ADDENDUM NO. 2

DATE OF ISSUANCE: 7/21/2026

PROJECT: AUTOMOTIVE TECHNOLOGY CENTER RELOCATION AND RENOVATION
8204 HWY 311, SELLERSBURG IN, 47172

ARCHITECT'S PROJECT NO.: 26-064

MECHANICAL PLATFORM
1/4" = 1'-0"

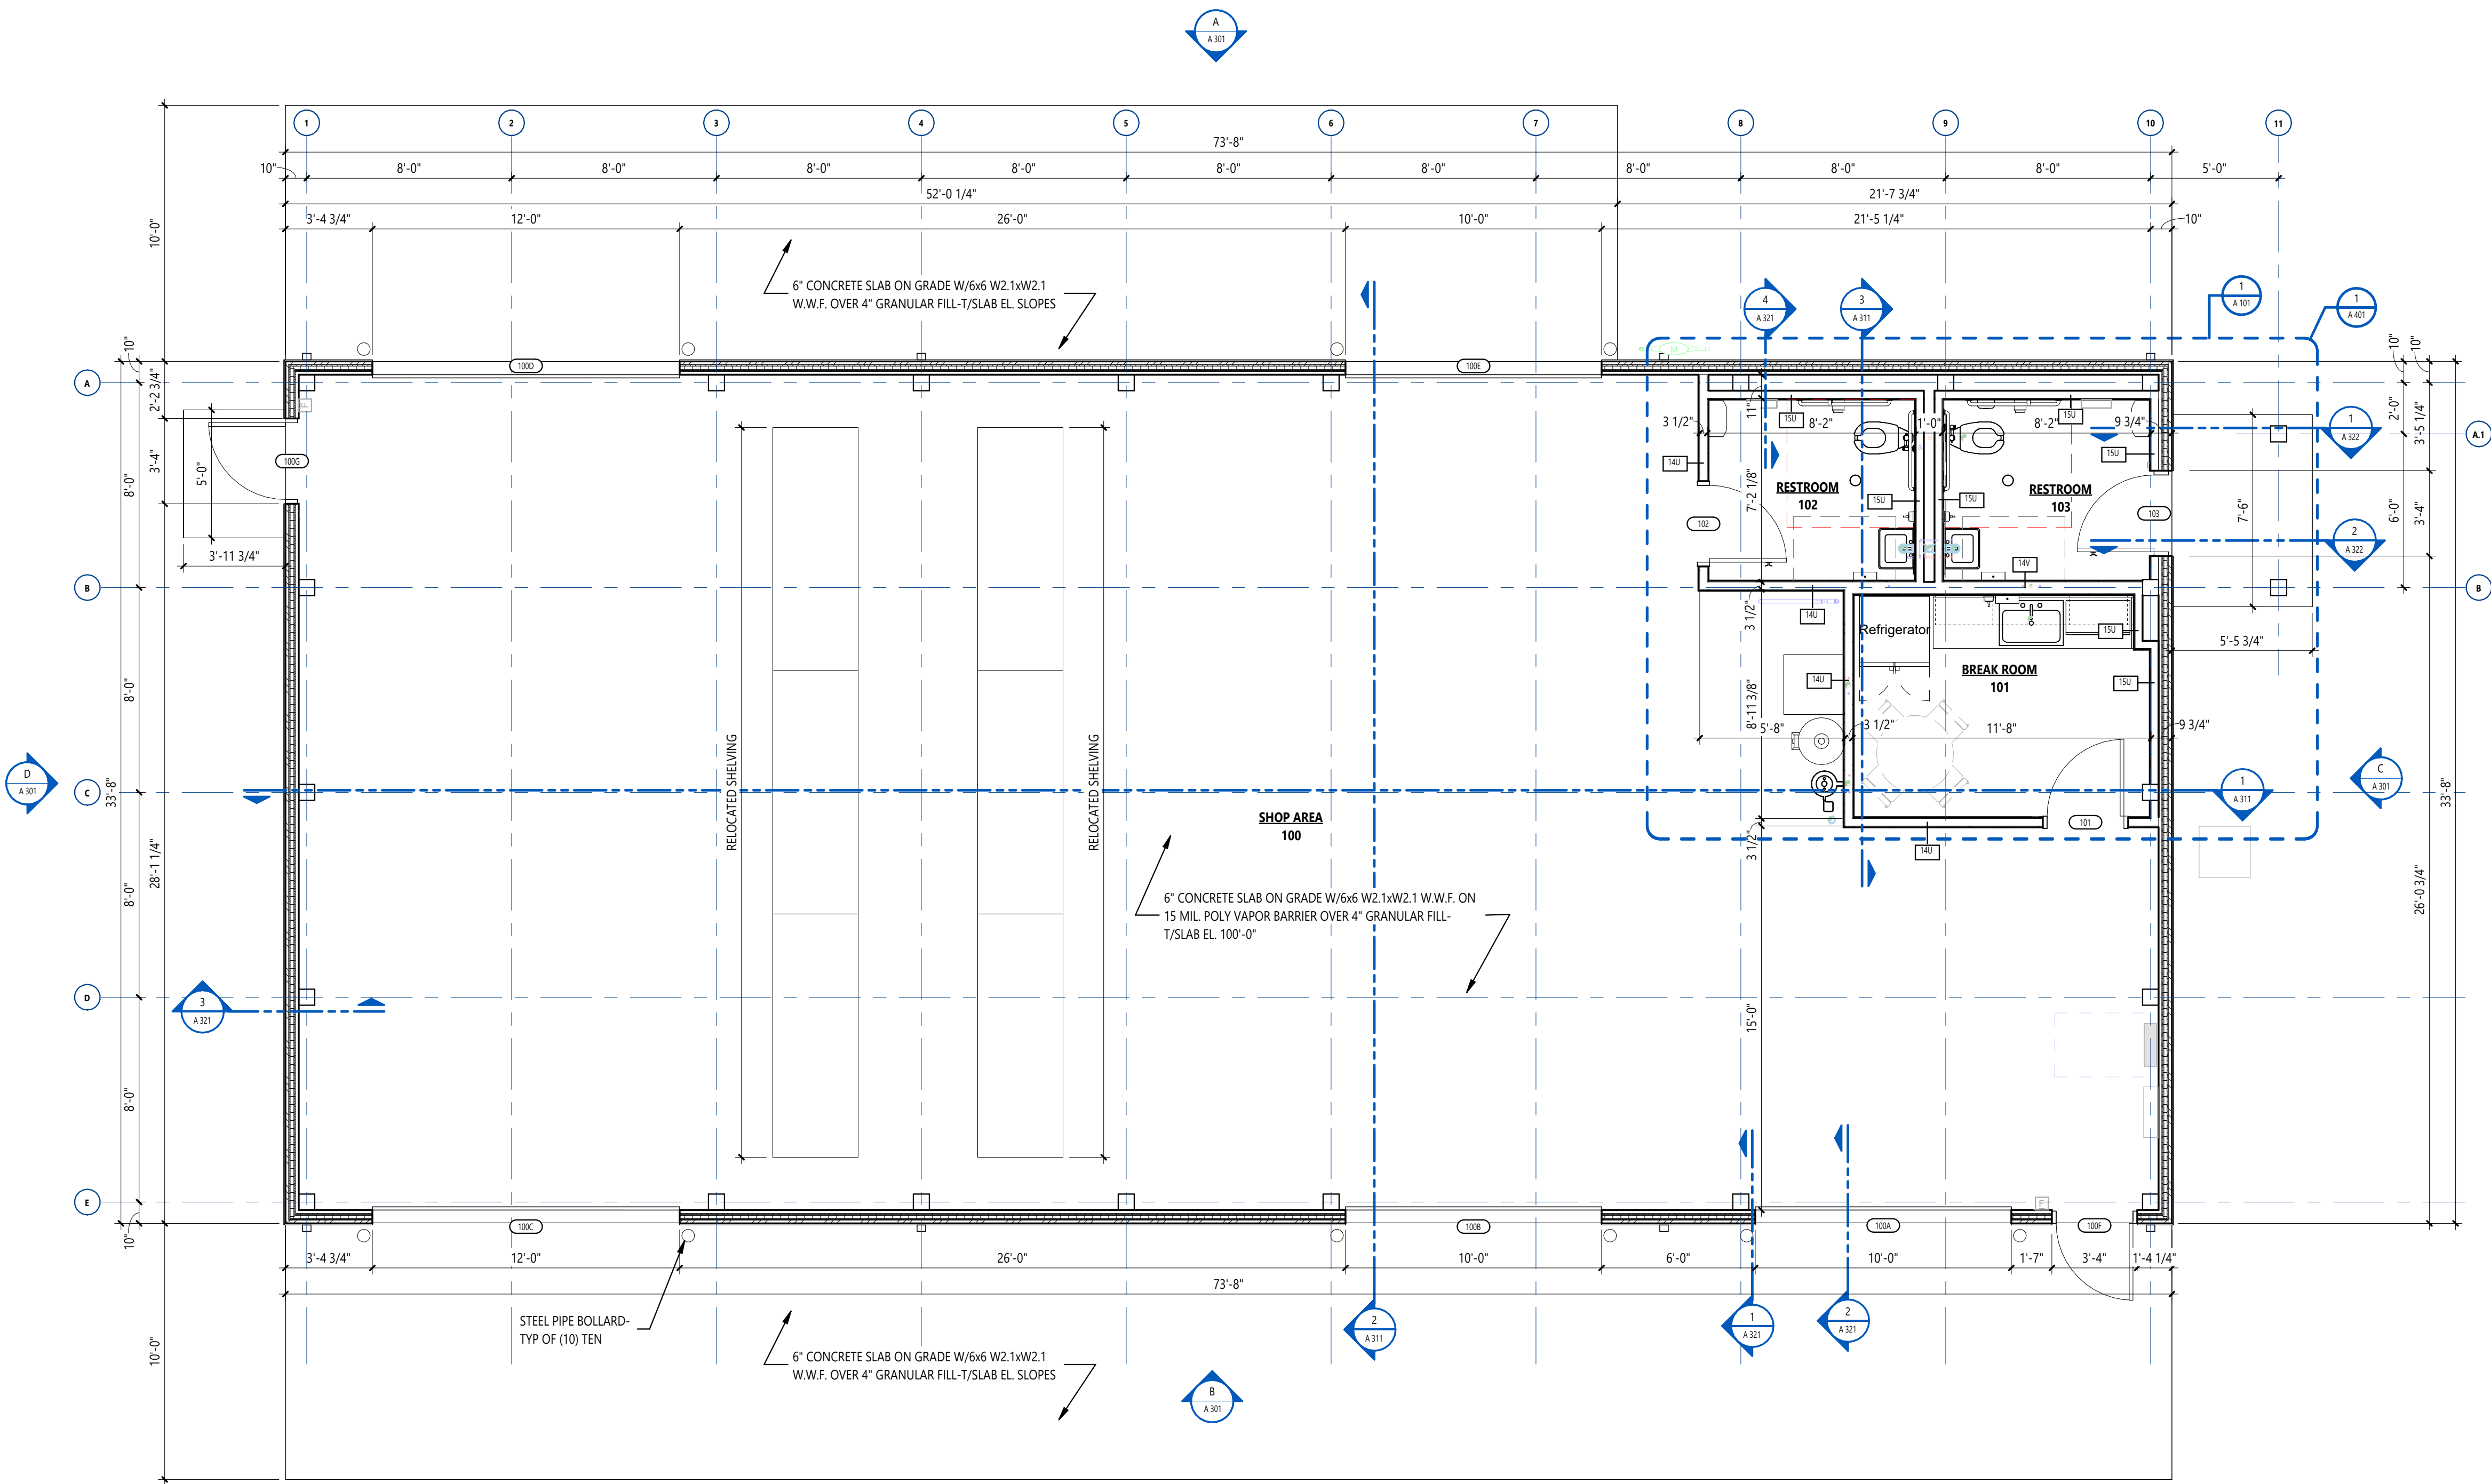
ADD-2: A 101

Added removable safety railing
